**SERVICE BULLETIN**

SB No. 77 Issue No. 1

**INSPECTION OF OIL COOLER DUCT TO ENGINE MOUNTING FRAME CLEARANCE**

**APPLICABILITY:** T67M260-T3A Pre Mod M628

FIG 1

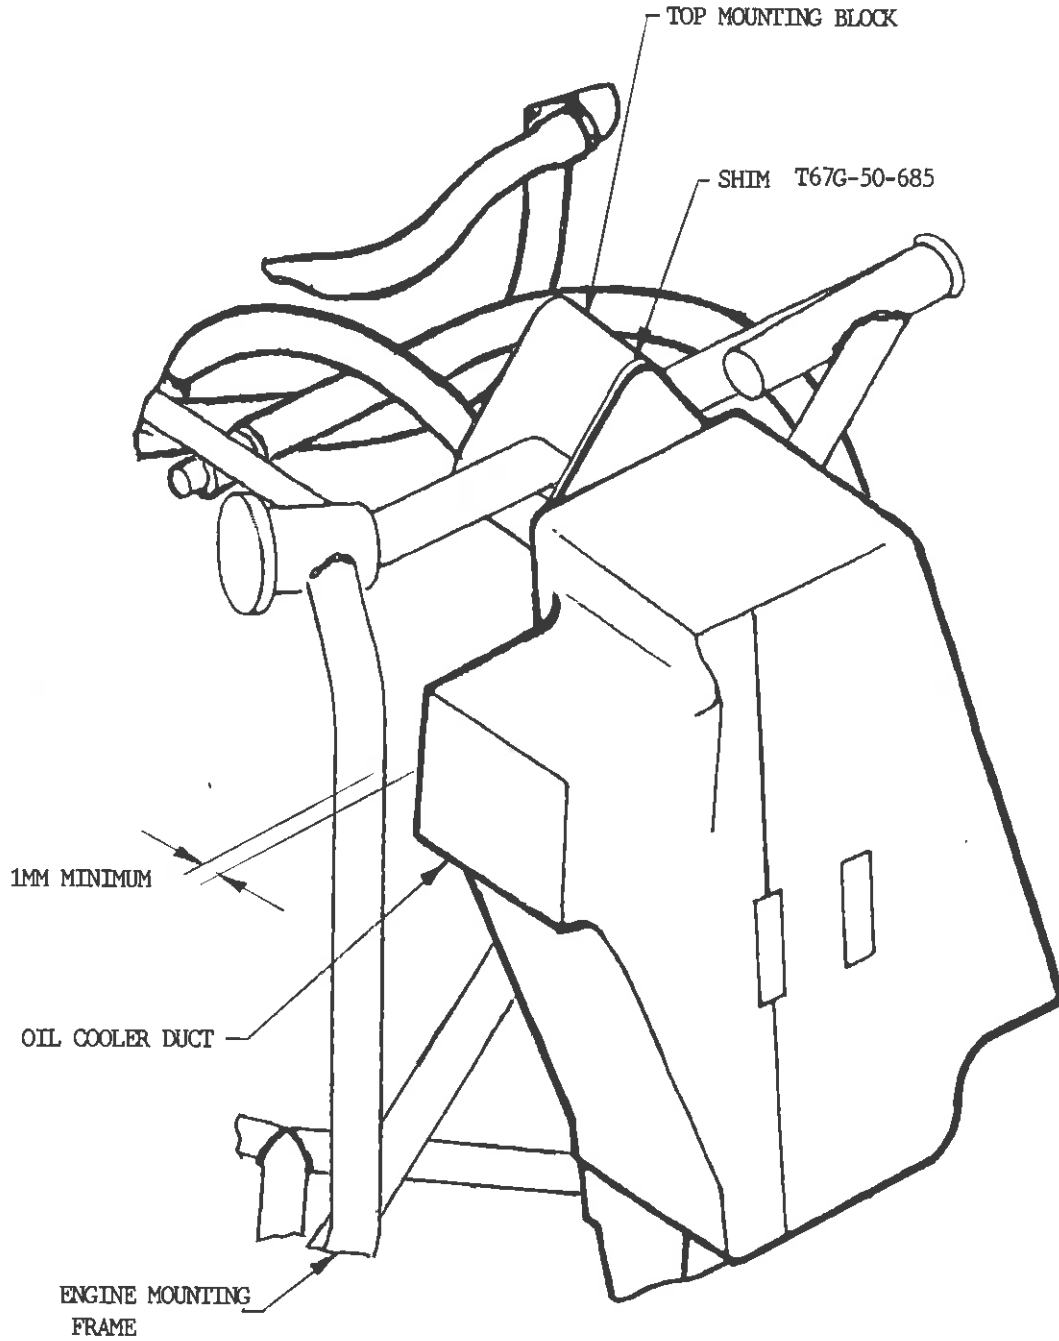
It has been reported that on a few aircraft the oil cooler glass fibre duct has been rubbing against the engine mounting frame.

1. Remove cowlings.
2. Check for scrubbed paint on engine mounting frame ref. Fig. 1.
3. Check that at least 1mm clearance exists between duct and engine mounting frame.
4. If mounting frame is worn or clearance less than 1mm, fit shim T67G-50-685 where indicated by Fig. 1.
5. Annotate in log book Mod M660 applied if shim fitted.
